Subject: MHI's Response to US-APWR DCD RAI No. 297-2287 Revision 2

MHI's Response to US-APWR DCD RAI No. 297-2287 Revision 2

**US-APWR Design Certification
Mitsubishi Heavy Industries
Docket No. 52-021**

RAI NO.: NO. 297-2287 REVISION 2
SRP SECTION: 15 – INTRODUCTION – TRANSIENT AND ACCIDENT ANALYSES
APPLICATION SECTION: 15.0.0
DATE OF RAI ISSUE: 5/04/2009

Figure 15.0.0-3.41 Temperature of Intact Loop with EFW versus Time with and without LOOP Feedwater System Pipe Break - RCS Pressure Analysis

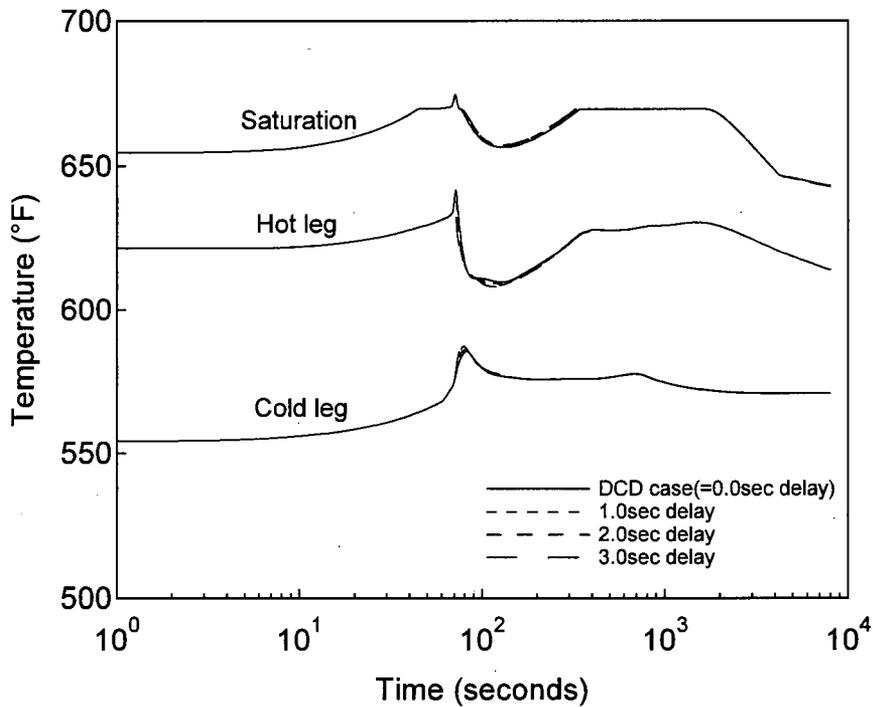
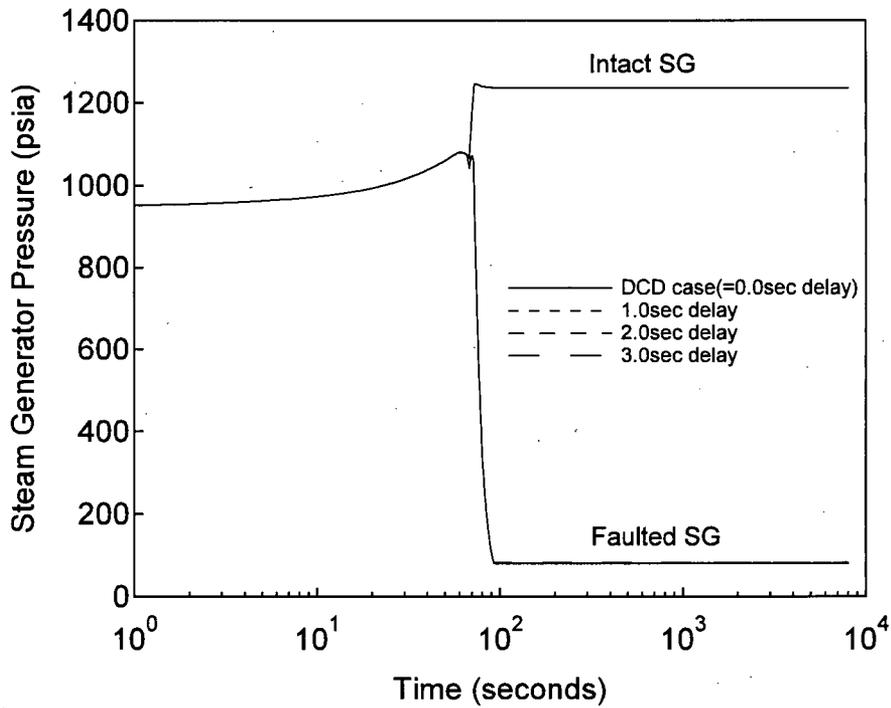
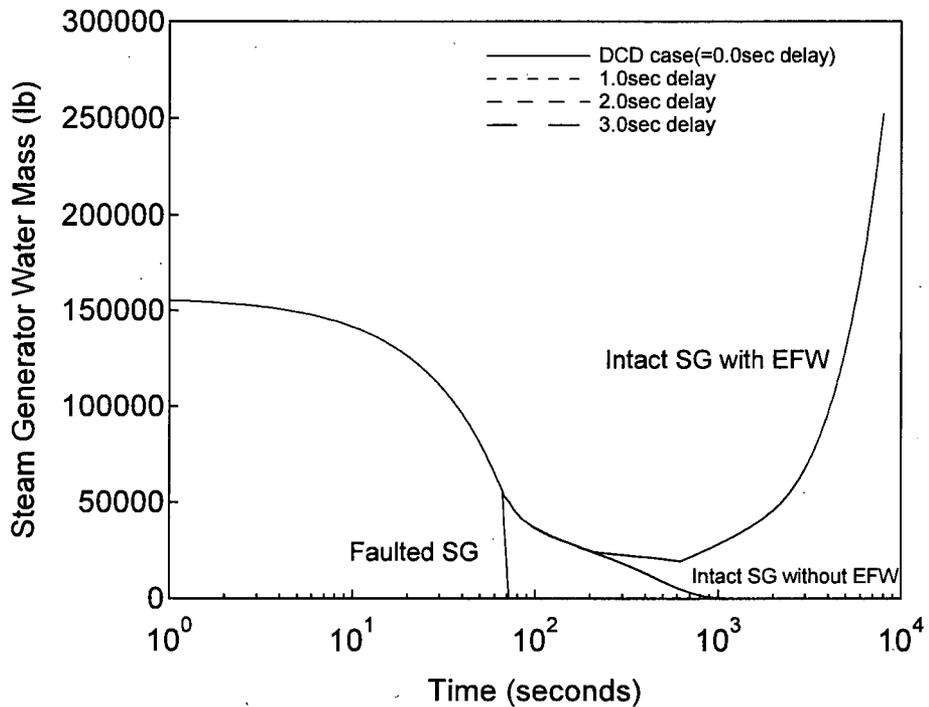
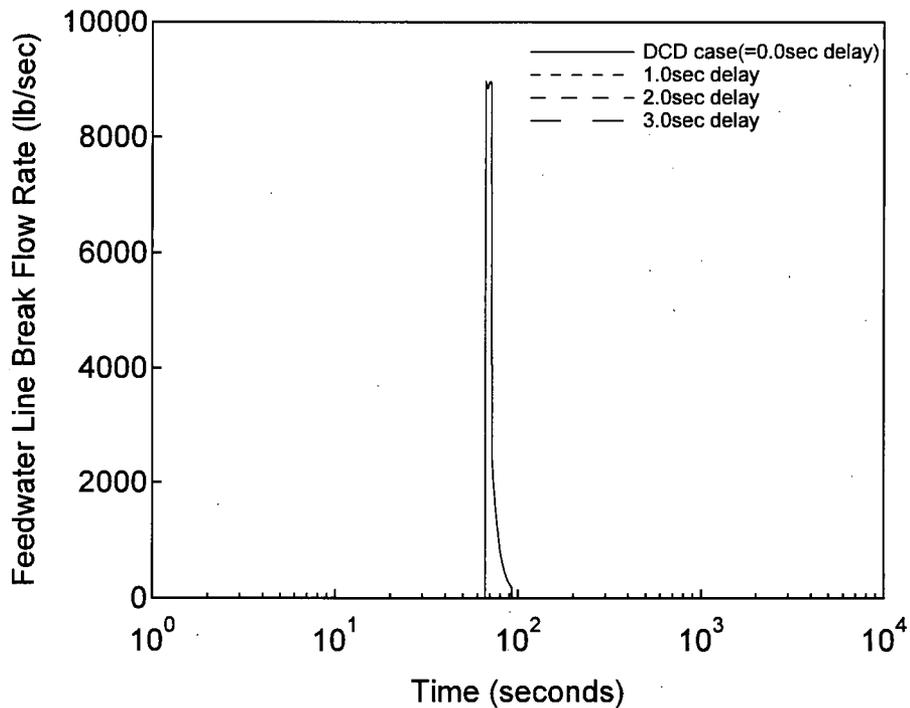
In DCD Section 15.0.0.7, the applicant presents arguments concerning the timing of a LOOP with respect to the timing of reactor trip and RCP coast down. By assuming a time delay in the onset of a LOOP, the onset of DNBR is decoupled from the availability of offsite power because the rods are inserted to the dashpot by the time the LOOP is initiated; therefore, the RCPs continue to run until the rods have been inserted in the core. This argument repeats itself throughout many Chapter 15 scenarios, allowing for the neglect of any LOOP consequences. Please provide more substantial arguments in defense of this assumed time delay, supported by sensitivity calculations that directly address this issue. (see also Question 15.1.2-1).

Two representative events were evaluated using MARVEL-M to assess the impact of the assumed LOOP delay time on the peak pressure: loss of load (Subsection 15.2.1) and feedwater line break (Subsection 15.2.8). Transient results for the key analysis parameters for the loss of load event with LOOP are provided in Figures 15.0.0-3.26 through 15.0.0-3.32. For the RCP outlet pressure shown in Figure 15.0.0-3.27, the cases with 2 and 3 second delay times have peak pressures that

are bounded by the DCD case, while the cases with 0 and 1 second delay times have slightly higher peak pressures than the DCD case. However, the difference in peak pressure is very small and in all cases, the peak pressures meet the relevant acceptance criteria. Transient results for the key analysis parameters of the feedwater line break event with LOOP are provided in Figures 15.0.0-3.33 through 15.0.0-3.44. It is important to note that the DCD feedwater line break case already assumes LOOP occurs with a 0 second (as opposed to a 3 second) delay time. The figures show that all parameters are mostly insensitive to the LOOP assumption. The relatively small differences in LOOP delay times are insignificant compared to the relatively long duration of the feedwater line break event. The DCD case shown in Figure 15.0.0-3.34 (which assumes a LOOP with 0 seconds delay) does have a slightly higher peak RCP outlet pressure than the other cases, but in all cases, the peak pressures meet the relevant acceptance criteria.

The results of the peak pressure analysis of these two events show that peak pressure is not as sensitive as DNBR to the LOOP assumptions. With a 3, 2, or 1 second delay between the turbine-generator trip and LOOP, the peak pressure is the same for the case with and without LOOP. The peak pressure is slightly higher for the 0 second delay case, but still within the acceptance criteria. Since the two events selected for this sensitivity analysis were the most limiting peak pressure events in Chapter 15, the remaining peak pressure analyses in Chapter 15 would also be adequate regardless of the assumptions about the LOOP delay time. While the results of this sensitivity analysis show that the DCD analyses meet the acceptance criteria, the description of the LOOP assumptions for peak pressure analyses in DCD Section 15.0.0.7 will be revised to more accurately describe the results of this sensitivity study.
